**STAFF RECOMMENDATION**  
**421 Broadway**  
**August 16, 2017**

**Application:** New Construction, Illumination, and Signage-violations  
**District:** Broadway Historic Preservation Zoning Overlay  
**Council District:** 19  
**Map and Parcel Number:** 09306310800  
**Applicant:** Good Times, LLC  
**Project Lead:** Paul Hoffman, paul.hoffman@nashville.gov

<p><b>Description of Project:</b> String lighting with poles attached to railings have been installed and neon wall signage added above the entrance without a Preservation Permit.</p>	<p><b>Attachments</b> <b>A:</b> Photographs</p>
<p><b>Recommendation Summary:</b> Staff recommends that the string lighting, poles and unpermitted signage be removed within 30 days, finding the project does not meet Section III.H for Additions, Section II.T. for Lighting, nor Section IV for Signage.</p>

Rooftop area at 421 Broadway

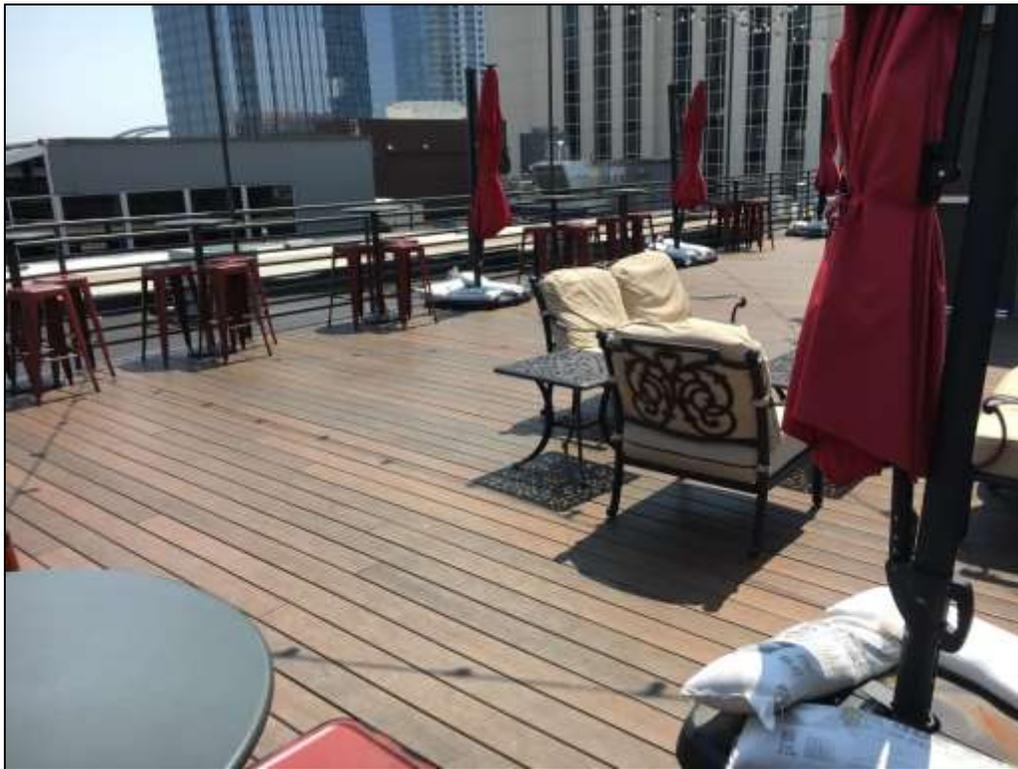
accordance with the district design guidelines. Recently the business installed poles with string lighting attached. (See figures 1 and 2.) New construction should step back from the front wall at least thirty feet (30') to ensure that new construction is not “visually jarring or contrasting” and that it is “minimal” compared to the historic building. Permanently- installed features forward of the thirty foot (30') set back do not meet the design guidelines. The project does not meet section II.H of the design guidelines for New construction-additions.

Illumination: The design guidelines call for lighting to be “simple and unobtrusive in design, materials and relationship to other façade or elevation elements.” String lighting and the requisite poles needed for installation of the lighting (see figure 2) are not appropriate in the stepback area as it is highly visible and the addition should be subordinate to the historic building. (In addition, the lighting may not meet code section 17.28.100 which does not allow for “excessive rope lighting,” which includes “strand lighting, lite ropes, flexible impact lighting, tubular lighting, string lighting, or other similar forms of illumination.”)

Staff recommends non permanently-installed lighting such as electric table candles or bollard lighting that does not extend above the parapet. The project does not meet section II.T for Lighting.

**Recommendation:** Staff recommends that the unpermitted signage, string lighting and poles be removed within 30 days, finding the project does not meet section III.H for Additions, Section II.T. for Lighting, nor Section IV for Signage.
